SEWAGE DISPOSAL SYSTEM

DEPARTMENT OF HEALTH AND MENTAL HYGIENE

HOWARD COUNTY HEALTH DEPARTMENT

REPAIR - PURPOSE - SEPTIC SYSTEM HAS FAILED.

GUILFORD RD INDICATE NORTH - NAME ADJOINING ROADWAY AS BASE LINE

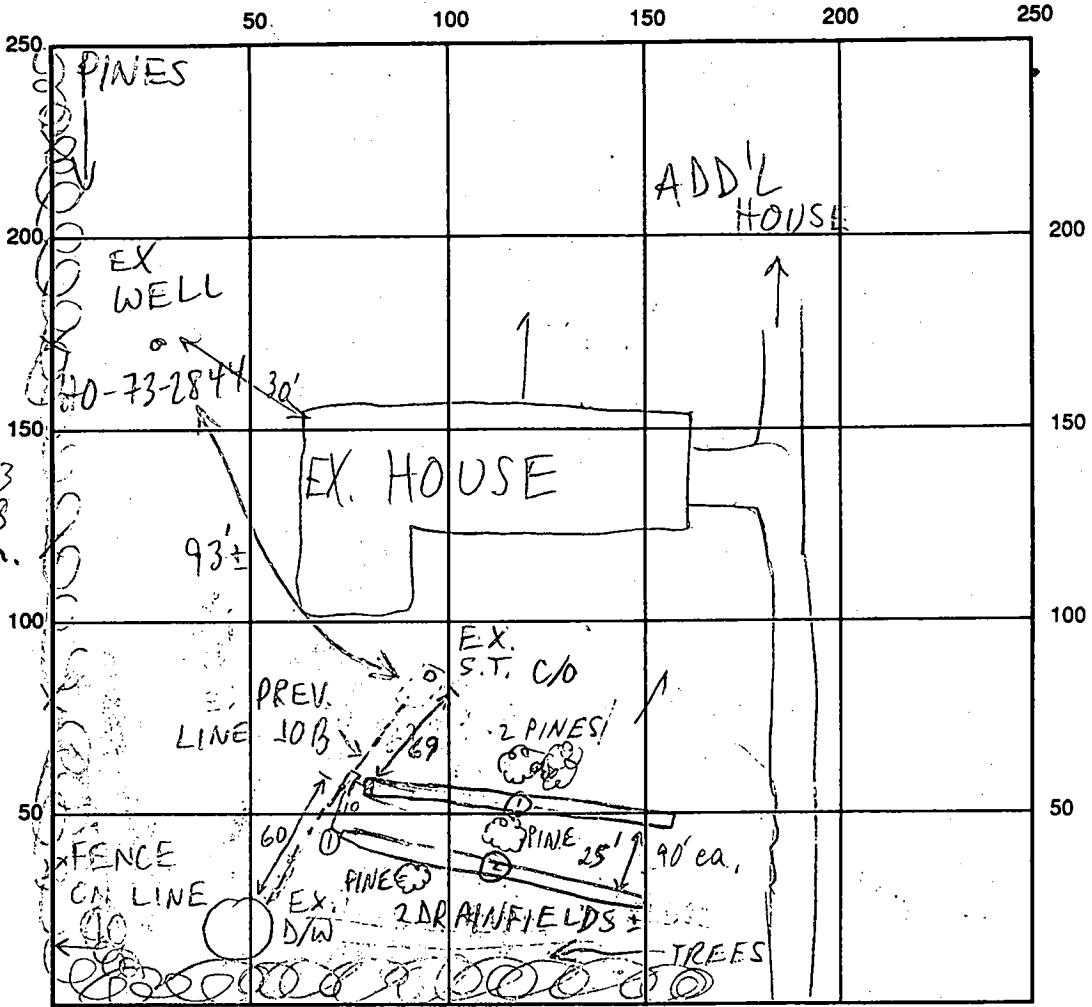
REMARKS: 5/10/96 #1 EX. D/W/DRAINFIELD IS TO REMAIN IN SERVICE, REPAIR SIZED @ 180 BR FOR SLOW SOILS, AND THE FACT THAT EX. SYSTEM LASTED ONLY 17 YEARS; CONTINUE MR
5/10/96 #2 OK TO COVER MR

INDICATE NORTH - NAME ADJOINING ROADWAY AS BASE LINE.

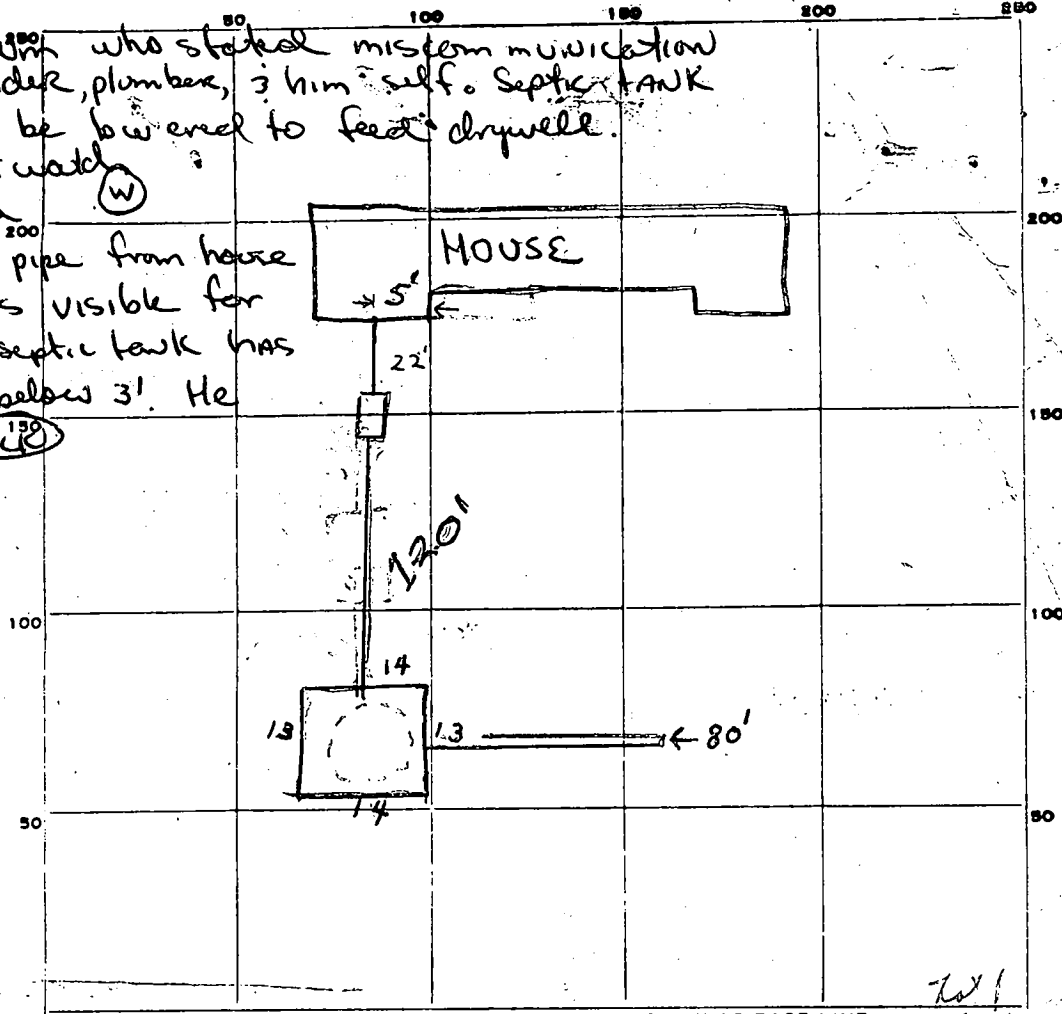
Contacted Kellum who stated miscommunication between builder, plumber, & him self. Septic tank may have to be lowered to feed drywell. Informed that watch be permissible providing all pipe from house to drywell is visible for inspection & septic tank has manhole 1" below 3'. He will call. (SLP)

REMARKS 10/3/78 Not ready { spoke to Mr. Kellum } To call in when ready
cc. B.S. briefly at site C.B.S.

10/6/78 Partial work to see house connection (see attached)

27 Feb 79 - House roughly complete - NO plumbing or house connection (GLK)

May 8 - everything complete except cement cleanout & provide caps F.F. & D.M.
DATE SYSTEM APPROVED 5-8-79 INSPECTOR J. [Signature]

R. Maiolatesi Property

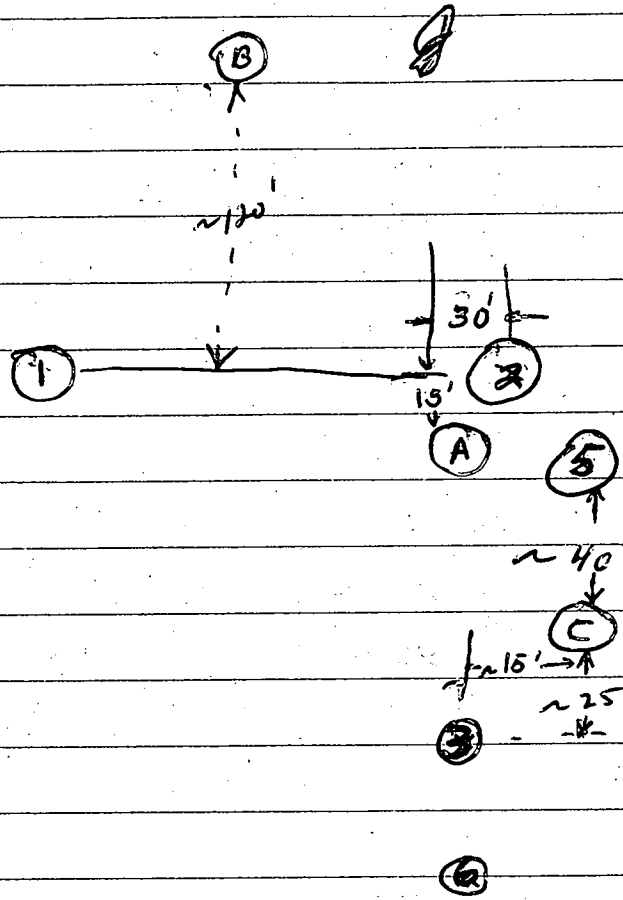
A - solid rock @ 5'

B - Water @ 7 1/4'; appears sandy fr 3'

C - 9 1/2' solid rock

C-1 - @ 4' - 3:20 → 3:35

Pulled peg
No movement

B-1 - @ 2 1/4' - 3:50 → 4:05

Pulled peg
Very little movement
